TITLE: Drive Interface		REV: 1.0
	Company: Your Company	Sheet: 1/1
	Date: 2020-10-05 Drawn By: mackelec

TITLE: Sheet_1		REV: 1.0
EasyEDA	Company: Your Company	Sheet: 1/1
	Date: 2020-10-12	Drawn By: mackelec

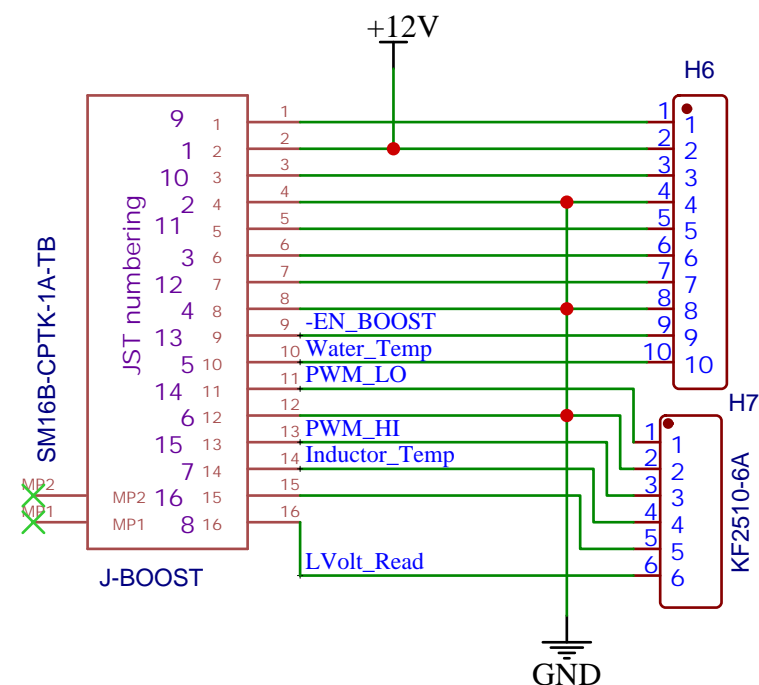
Unknowns	R - Gnd
1	1
2	2
3	3
4	4
5	5
6	6
7	7
8	8
9	9
10	10
30	9.8k
32	9.8k
43	20k
45	* 21.7k
46

?VHU = Bus Voltage ?

Connector Pins not laid out to JST spec
